## TECHNICAL BULLETIN

FAM-A-0078-C

### Removal of the UL Mark from Some MELSEC-F Series Models

FX3UC-32MT-LT-2, FX3U-64CCL, and FX3U-16CCL-M

Product	Model
Main unit	FX3UC-32MT-LT-2
Special extension blocks	FX3U-64CCL, FX3U-16CCL-M

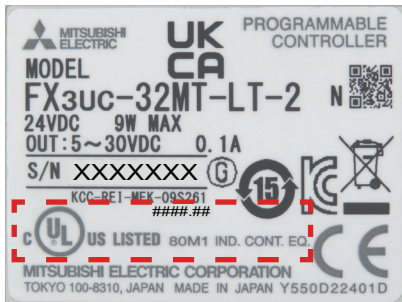
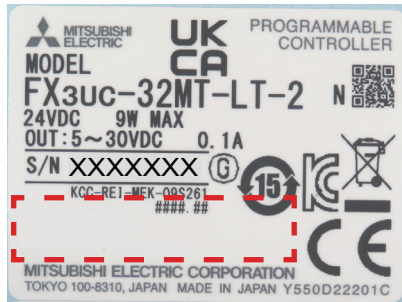
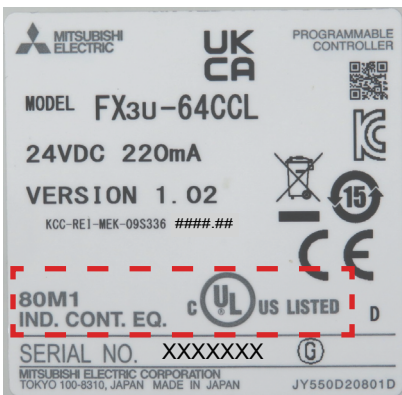
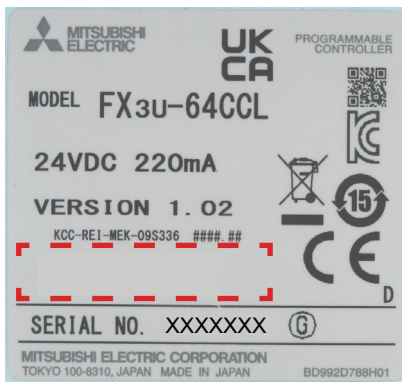
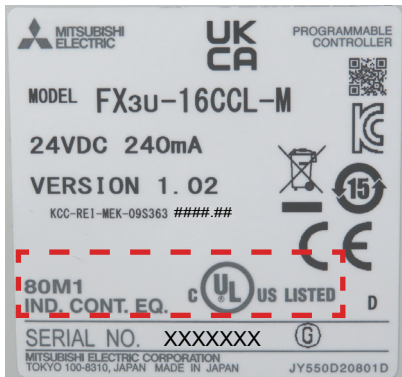
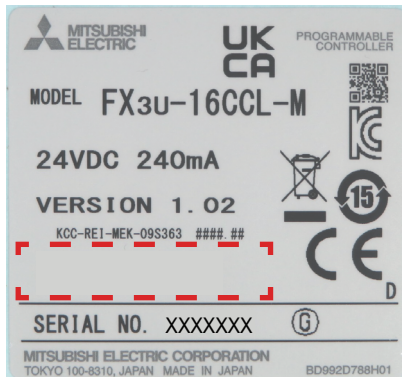
The following MELSEC-F series models were found to be incompatible with the UL certification due to differences from the certified content. This technical bulletin informs you that the UL mark will be removed from those models.

The UL mark will be removed from the rating plate as follows. In addition, the size and color of the plate will be changed.
